# Technical Service Information

## CHRYSLER 46RE DIAGNOSTIC TROUBLE CODE P1740

Figure 1

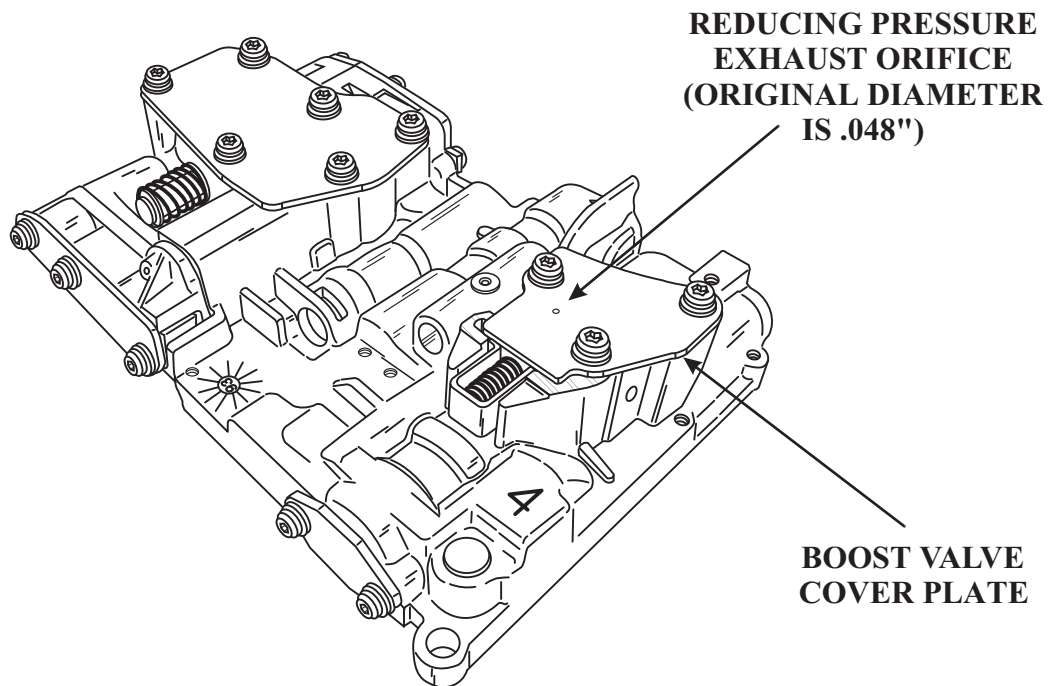
**CAUSE:** The cause may be, a Reducing Pressure Exhaust orifice that is too small, which delays the pressure increase needed when the Torque Converter Clutch is applied. Refer to Figures 2 and 3 for a partial hydraulic schematics explaining the Boost Valves function.

**REMOVE THE BOOST VALVE COVER PLATE AND  
ENLARGE THE REDUCING PRESSURE EXHAUST  
ORIFICE TO .069"**

**CORRECTION:** Refer to Figure 1 to locate the Reducing Pressure Exhaust Orifice, which is in the Boost Valve Cover Plate. Remove the plate and enlarge the orifice shown to .069."Chrysler also provides a new Boost Valve Cover Plate which will already have the orifice enlarged.
